Report Type: DA Access Report
Reference Number: 19210
Client: DKO
Site Address: 28 Lockwood Avenue, Belrose NSW

ACCESS REPORT

This Access Compliance Report is to accompany a Development Application for the development proposed at 28 Lockwood Avenue, Belrose NSW.

Basement 4 showing 3 accessible parking spaces allocated for Retail use.

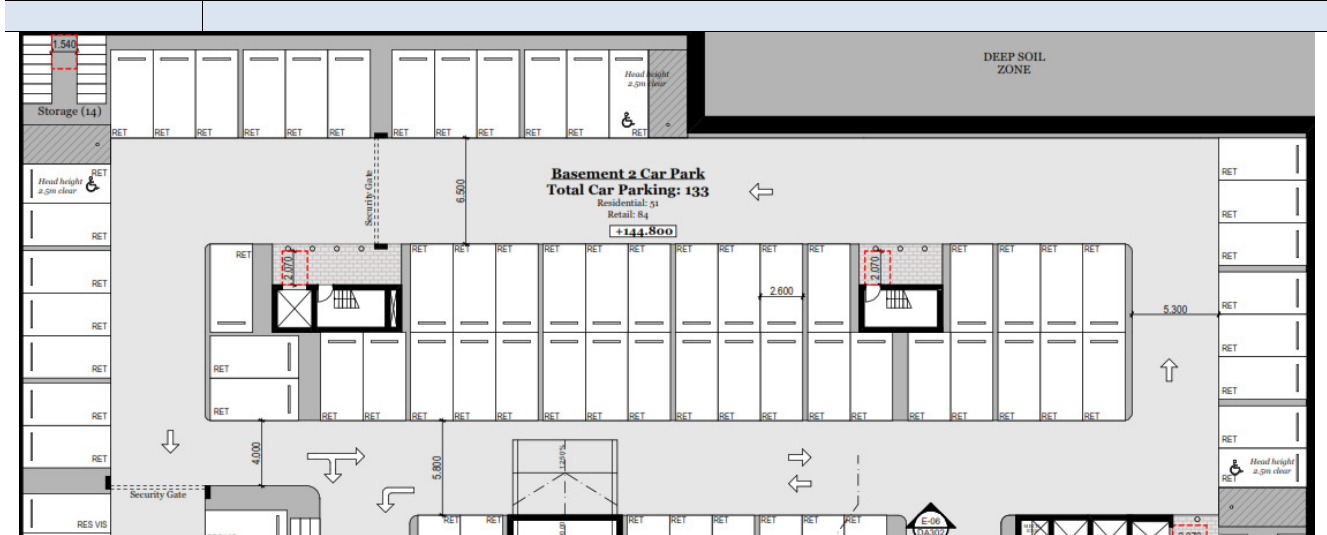
Requirement	Class 5, 7 - 1 Accessible car parking space per 100 carparking spaces Class 6 - 1 Accessible car parking space per 50 carparking spaces (up to 1000 spaces) and additional 1 Accessible car parking space per additional 100 spaces provided
Compliance Comments	Complies. Total number of parking spaces provided for the commercial / retail component of the development= 94 Total number of Accessible parking spaces required for the commercial / retail component of the development = 2 Total number of Accessible parking spaces provided for the commercial / retail component of the development =3 Detailed features of the accessible parking space to be verified at CC stage of works.

Accessible Entry

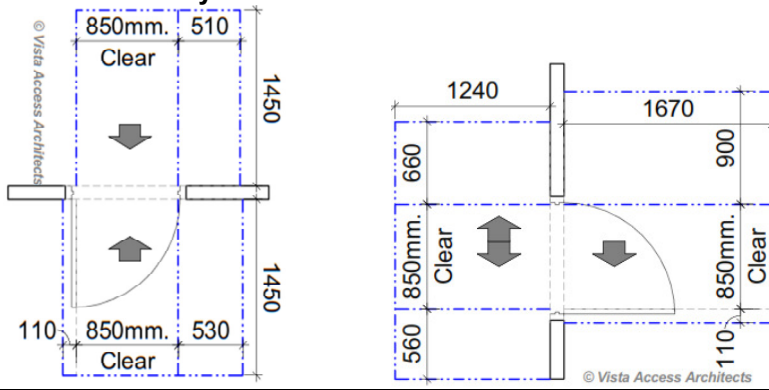
<p>Door circulation requirements of AS1428.1 with approach directions shown with arrows below. Accessible entry to be provided with,</p> <ul style="list-style-type: none"> - An accessible door threshold - 1550mm diameter landing - 850mm clear opening door with clearances, door hardware operable with one hand and located 900-1100mm above floor 	✓	✓	Capable of compliance. Details to be verified at the CC stage
<p>Interior: General</p> <ul style="list-style-type: none"> - Internal doors to have 820mm minimum clearance with provision for compliance with AS1428.1 for door approaches and minimum corridors width of 1M - Door hardware operable with one hand and located 900-1100mm above floor 	✓	✓	Capable of compliance. Provide an 850mm clear opening door to the adaptable bathroom and 1 main bedroom. Rest to have 820mm clear opening. Details to be verified at the CC stage
<p>Living room and dining room</p> <p>Circulation space of minimum 2250mm diameter.</p>	✓	✓	Complies.

Main bedroom

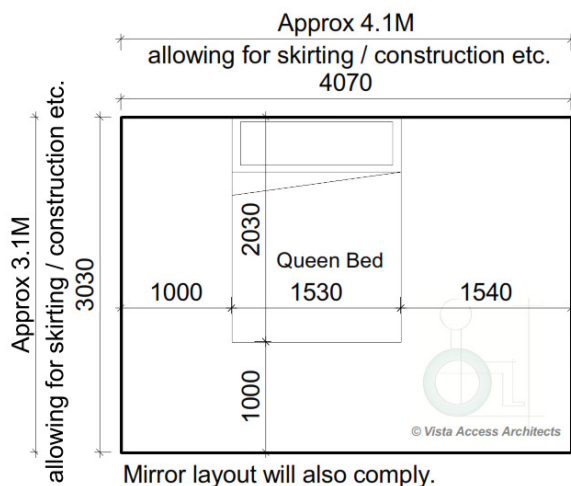
<p>At least one bedroom of area sufficient to accommodate a queen size bed and wardrobe and circulation space requirements of AS1428.2</p>	✓	✓	Complies Details to be verified at the CC stage
--	---	---	--

Main Adaptable bathroom

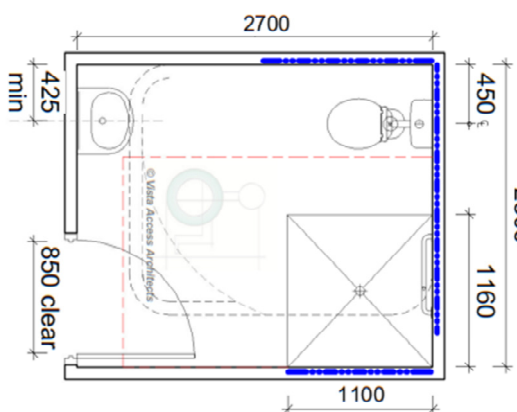
Noted dimensions in these diagrams are approximate and depend on selected features such as size of the basin. These dimensions include allowances for reinforcements and normal construction tolerances. Thick blue line indicates the location of wall reinforcements which are to be provided at pre-adaptation itself. Red dotted line indicates the shower circulation space. Black dotted line indicates the WC pan circulation space.

Wall reinforcement requirements at Pre-adaptation

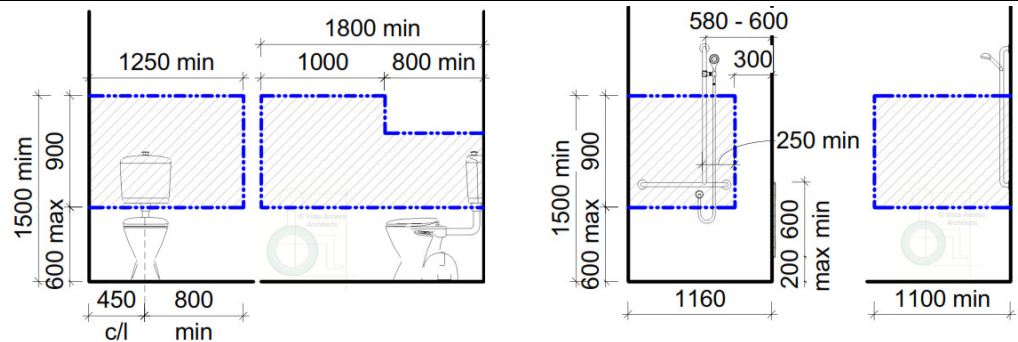
Reinforcement requirements for the Adaptable unit for WC and shower (in post-adaptive position) showed hatched. Refer to AS4299 for further details.
